1280 WEST PENDER STREET (COMPLETE APPLICATION)
DE408652 - ZONE DD

DEVELOPMENT PERMIT STAFF COMMITTEE RECOMMENDATION: APPROVE IN PRINCIPLE

THAT the Board APPROVE IN PRINCIPLE the concept of developing this site with a residential tower along with a podium containing townhouses on Melville St. and retail uses at grade on W. Pender St., and a 4 ½ level underground parkade accessed from the adjacent 1211 Melville site, and incorporating a transfer of 736.8 m² of heritage density from a vendor site, as submitted under Development Application No. DE408652, subject to the following conditions:

Fig.1: VIEW IMPACTS ON POINTE CLAIRE: PROPOSED WEST TOWER ("FLATIRON")

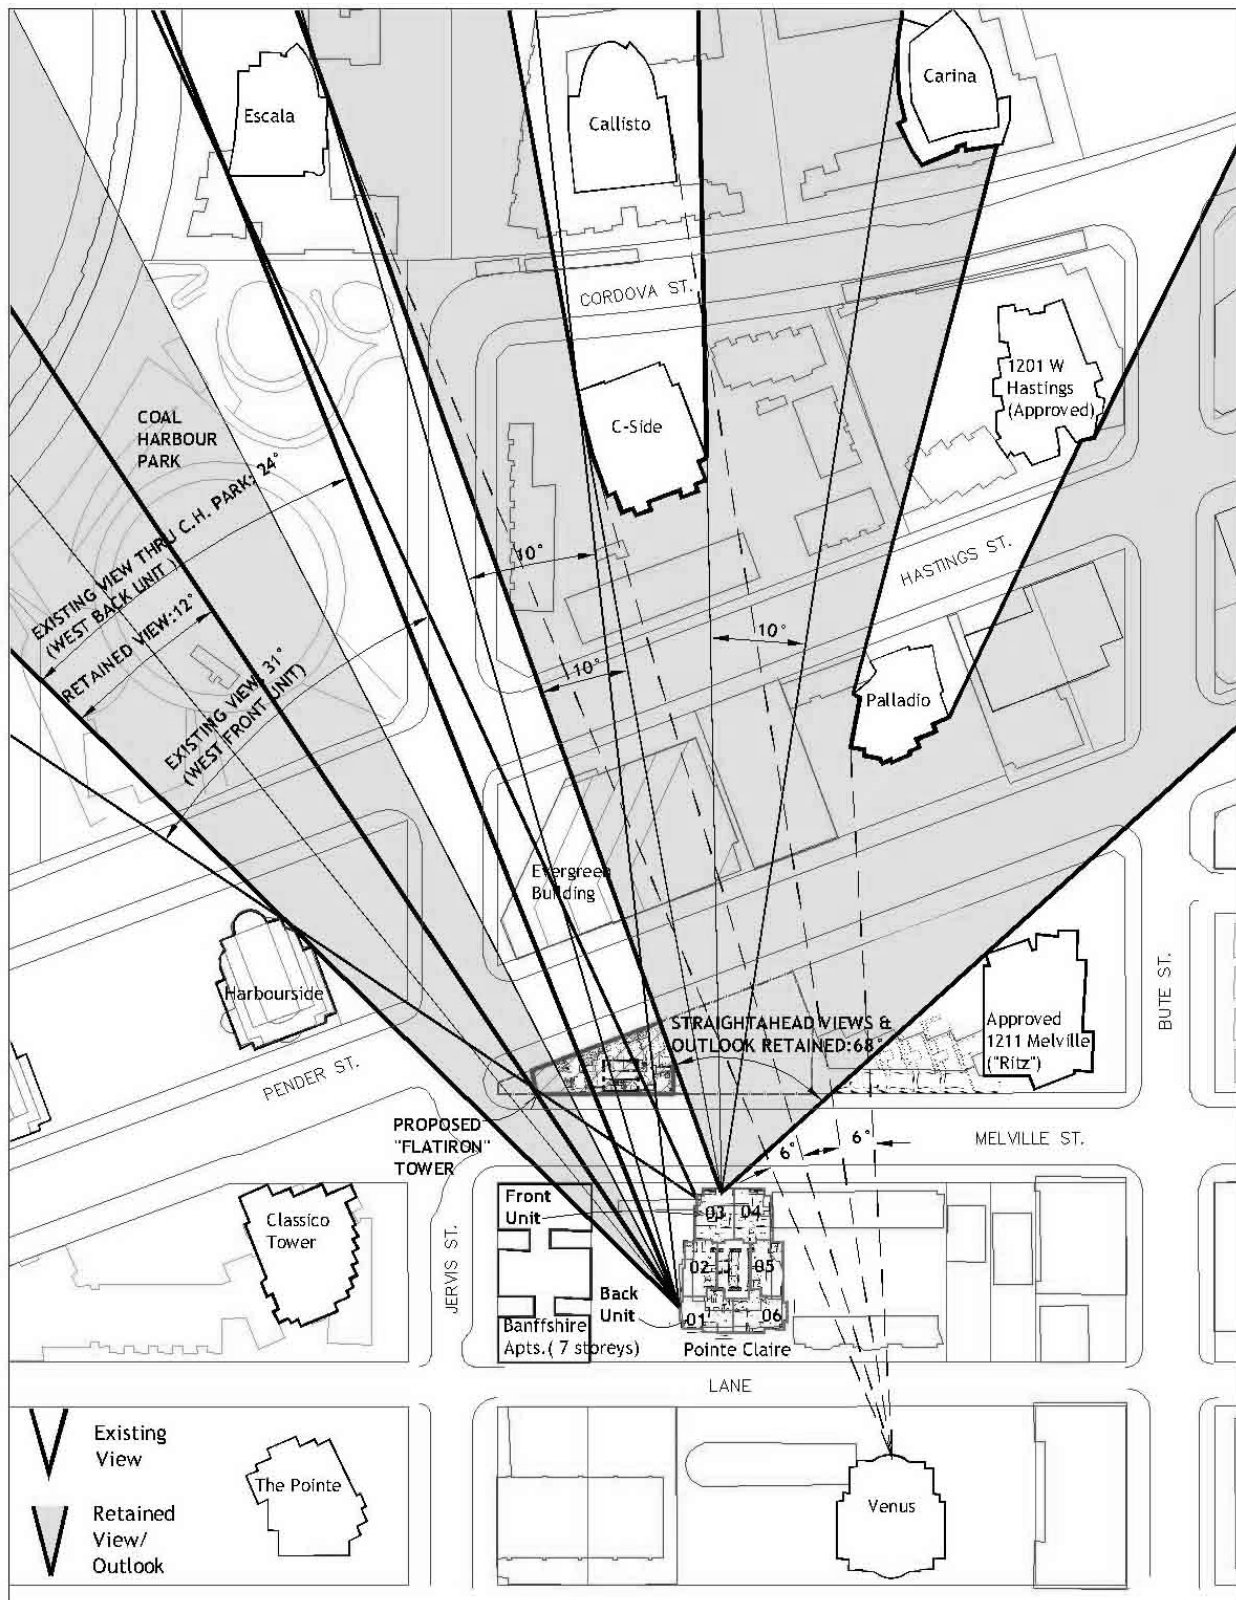
Tower Location: The proposed tower is positioned at the narrow, west side of the site close to the Jarvis/Melville corner, and configured as an elongated, triangular "Flatiron" form 30.2 m (99 ft.) wide to respond to the unique street intersection pattern. The site's unusual shape and narrow depth constrain potential tower locations, particularly in respect to underground parking which favours a westerly tower option because of difficulties accommodating a tower's elevator core within the constricted parking layout. More importantly, a tower located at the easterly side of the site, however slim would be directly in front of the Pointe Claire tower, separated from it by only 21.3 m to 22.9 m (70 - 75 ft.) across Melville Street (Note: The Pointe Claire tower is set back only 1.2 m (4 ft.) from the Melville St. property line). This potential close interface between towers would raise privacy concerns for approximately 62 to 68 front units in the Pointe Claire above the 4th floor. The typical tower positioning pattern encouraged in the downtown is to offset towers from each other wherever possible so that neighbouring residents are not looking directly at each other. In addition, separation between towers of 24.4 m (80 ft.) is sought.

While acknowledging that a tower located at the east side of the site would have fewer view impacts on west-facing units in the Pointe Claire, staff are concerned that such an option would compromise livability and privacy for front units. However, recognizing the significant concerns raised by the Pointe Claire and Banffshire Apartments, staff investigated whether the view impacts of a west tower option could be substantially diminished through a notably reduced tower width and increased corner setback while retaining the advantages of a westerly position, as well as the architectural concept of a "flatiron" shape (see **Private Views**; p.9).

Private Views: The applicant has examined, through a detailed quantitative view analysis, the impacts of the proposed tower location and height on private views from a number of nearby tower locations (Appendix F). This analysis compared view impacts from the proposed "Flatiron" to an alternative compact tower floorplate [26.6 m (74 ft.) wide] located close to the east edge of the site. The applicant's conclusion is that the proposed scheme has fewer view impacts for the several affected neighbouring buildings in terms of "degrees of open view maintained" than the alternative east tower option. In particular, the study examined impacts on four existing residential towers within one block of the site that would be most affected ("Pointe Claire", "Venus", "Classico" and "The Pointe").

Fig.2: VIEW IMPACTS ON POINTE CLAIRE: ALTERNATIVE EAST TOWER*

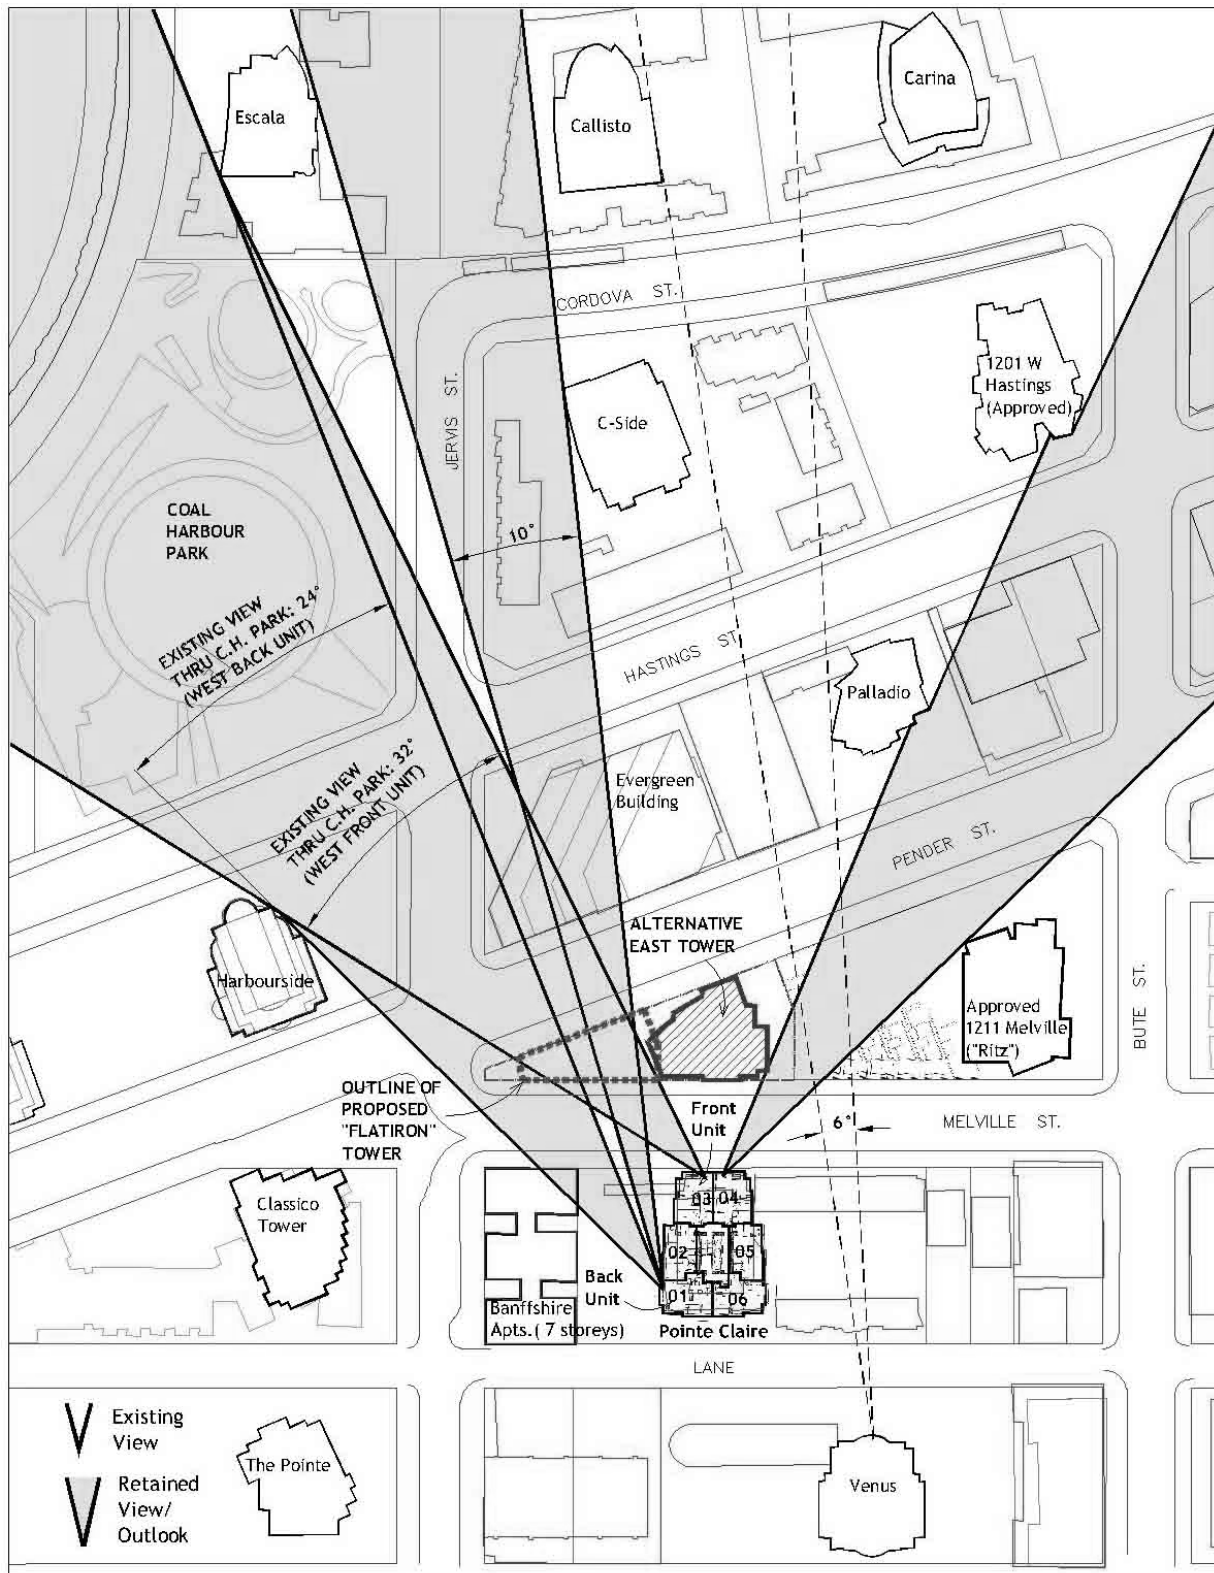
Note: If accepted by the D.P. Board, the modifications outlined in Condition 1.1 would be accompanied by a slight eastward shift of tower and its core of 2.5 m (8.2 ft.) so as to preserve proposed floor plate area of approximately 323.5 m² (3,481 sq. ft.) with its suite layouts and orientation, while still maintaining the tower offset from the Pointe Claire, albeit slightly reduced. The comparative view implications of this modified west tower vs. an alternative east tower option are diagrammed in Fig. 2 and Fig. 3 (pages 13 & 14).

*Note: The alternative east tower floorplate shown has been slightly adjusted from the applicant's version in order to improve diagonal views from Pointe Claire front units.

Fig.3: VIEW IMPACTS ON POINTE CLAIRE: MODIFIED WEST TOWER (RECOMMENDED)

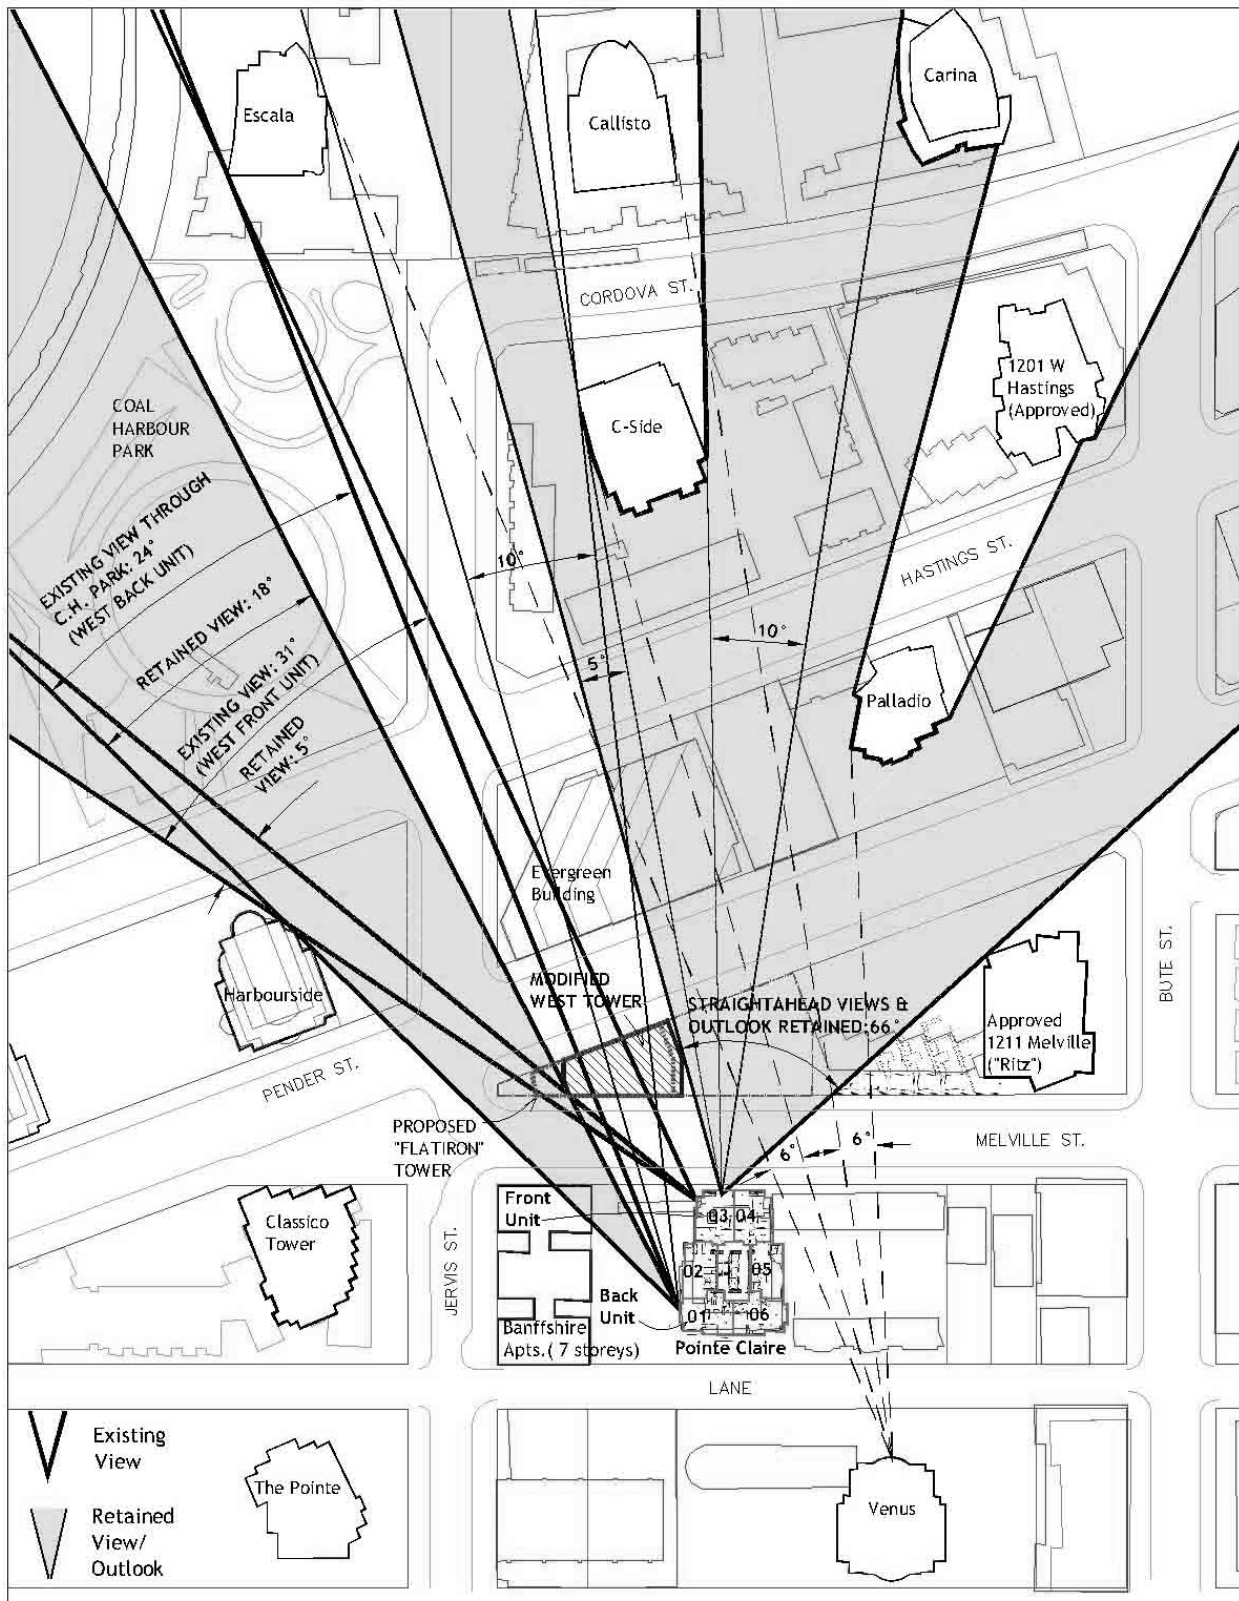
In addition to reducing view impact on the Pointe Claire and Banffshire Apartments, the recommended increased setback from Jervis Street will also increase the area of the open corner plaza, enhancing the public realm by creating, along with the mini-plaza of the "Classico" across Jervis St., a unique "urban room" framed by the Banffshire Apartments and the proposed tower (see Public Realm/Open Space; page 15).

1.1 design development to modify the proposed tower siting and east/west dimension (width) to reduce impacts on private views from upland neighbours, in particular the Pointe Claire tower and Banffshire heritage apartments, by:

- reducing its east-west dimension (Melville St. property line) from 30.2 m (99 ft.) to a maximum of 25 m (82 ft.);and
- increasing the tower setback from Jervis St. by 8 m (26.2 ft.) along the Melville St. property line to achieve a minimum setback of 16.5 m (54 ft.);

Note to Applicant: These adjustments anticipate shifting the tower slightly east by approximately 2.5 m (8.2 ft.) to maintain the proposed typical floorplate area of approximately 323.5 m² (3481 sq. ft.) but being mindful of the objective of 80 ft. tower separation from the Pointe Claire. Removal of the projecting westerly vertical glass fin is also required.
